**AUSTRALIAN BUILDING CODES BOARD
PROPOSAL FOR CHANGE TO THE NATIONAL
CONSTRUCTION CODE 2019
COMMUNICATIONS ALLIANCE
AUGUST 2017**

**PROPOSAL FOR CHANGE
NATIONAL CONSTRUCTION CODE SERIES**

SUBJECT	Telecommunications pathways and spaces
BCA Volume One:	New Part F6 Telecommunications
BCA Volume Two:	New 3.8.3.4 and 3.8.3.5 Telecommunications pathways and spaces; Installation requirements
Guide to Volume One:	N/A
PCA Volume Three:	N/A

Buildings located within and not within the fixed line footprint

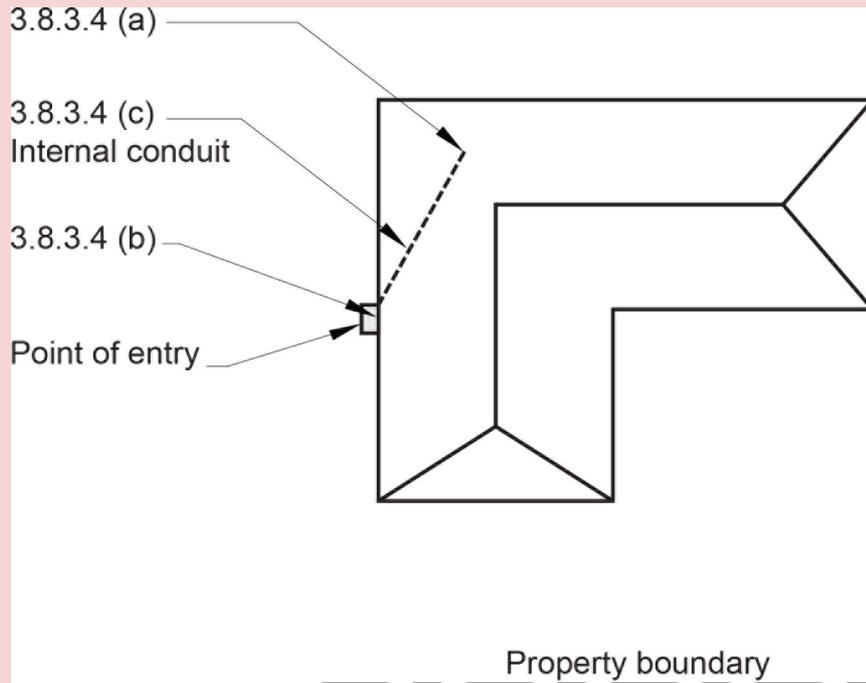
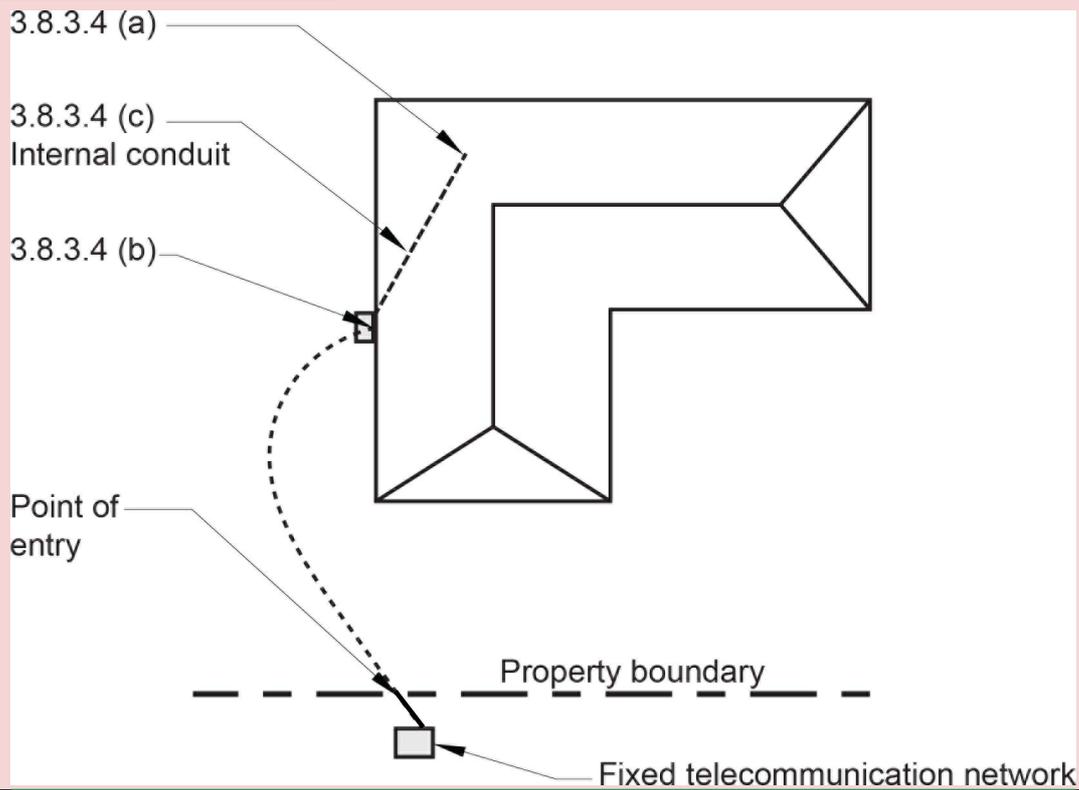
3.8.3.5 Installation requirements

A *telecommunications pathway* required by 3.8.3.4 must—
